From: Wickham, Jerry, Env. Health
Sent: Monday, August 29, 2011 11:33 AM
To: Jeff Setera
Cc: Miller, Charles GSA - Technical Service Department; mkuykendall@sandis.net; 'Logan Medeiros'; 'Peter Langtry'; 'Paul Beamer'; 611021@sandis.net; 'Nathan Allen'
Subject: RE: 611021 - Ashland Revised Soil Sampling Plan

I have reviewed the Revised Soil Sampling Plan consisting of a Revised Sampling Location Map and the text referenced below for case RO0212. The proposed sampling is acceptable with the same two conditions listed below that were provided in our previous comments:

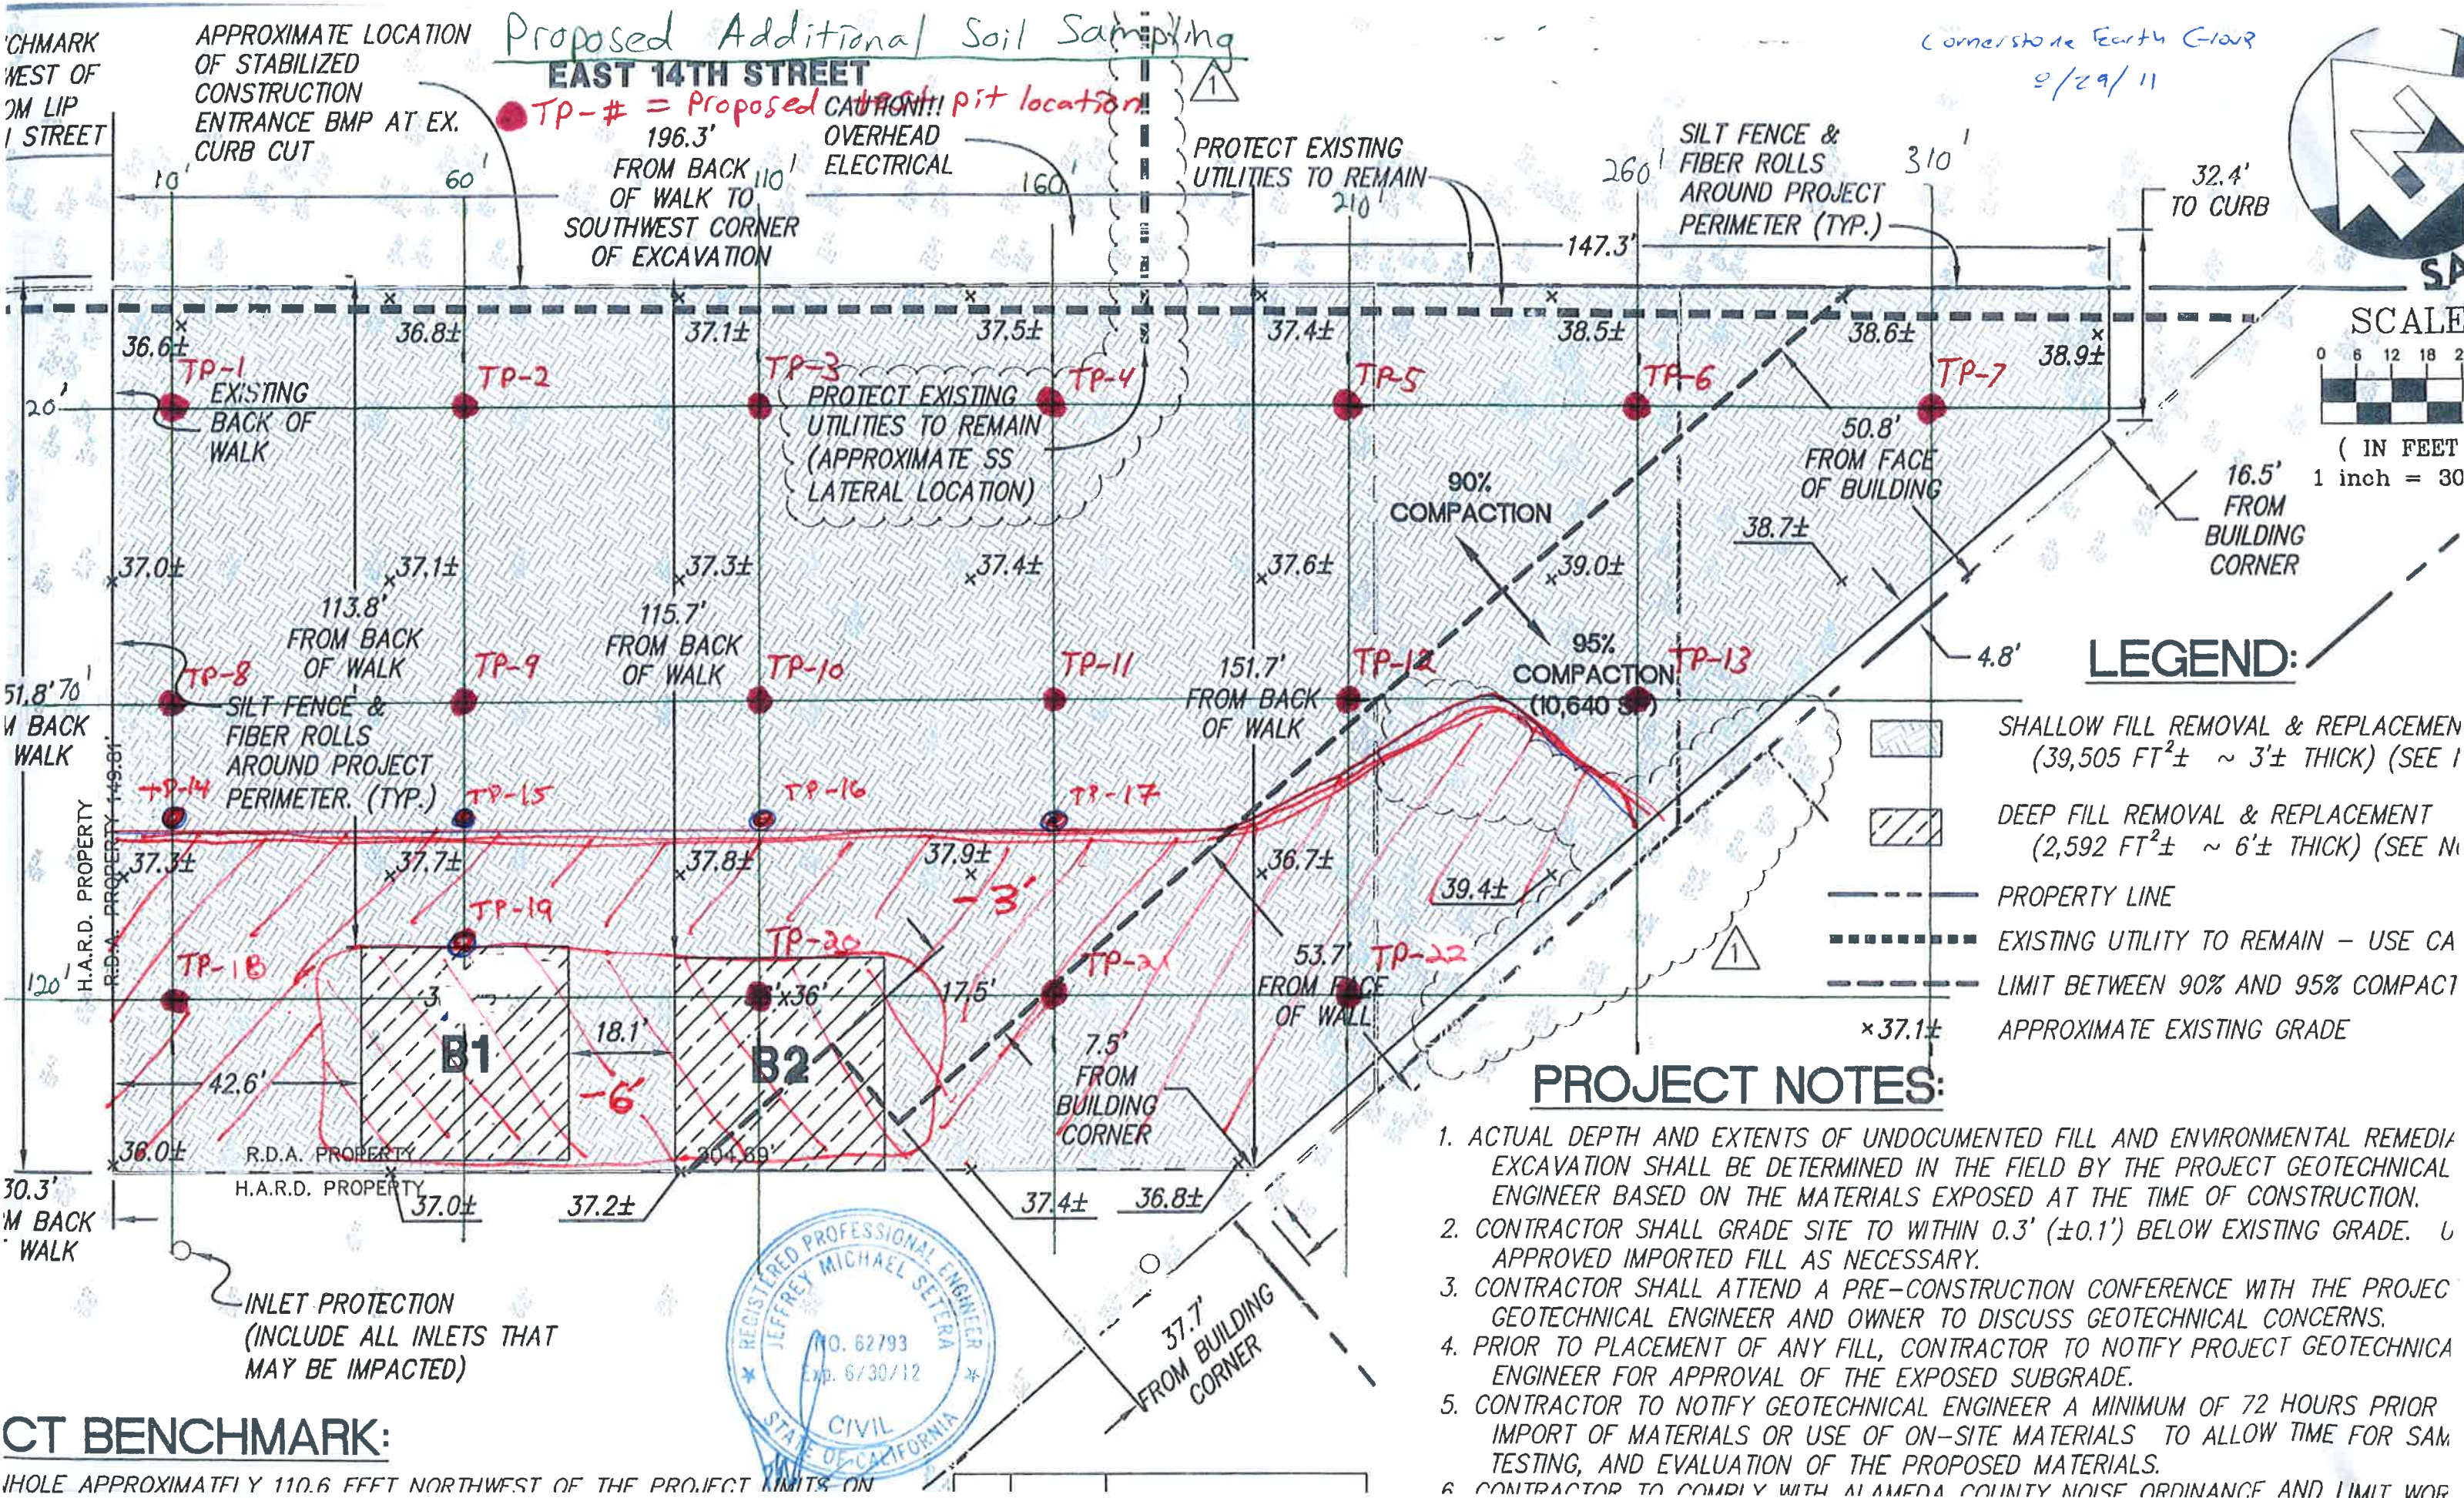
- 1) If visual staining, odor, elevated PID readings, or other obvious signs of contamination are observed in a test pit, the fixed sample intervals will be adjusted or additional soil samples will be collected as necessary to characterize the contamination.
- 2) The conditions in each test pit will be logged by a qualified engineer or geologist.
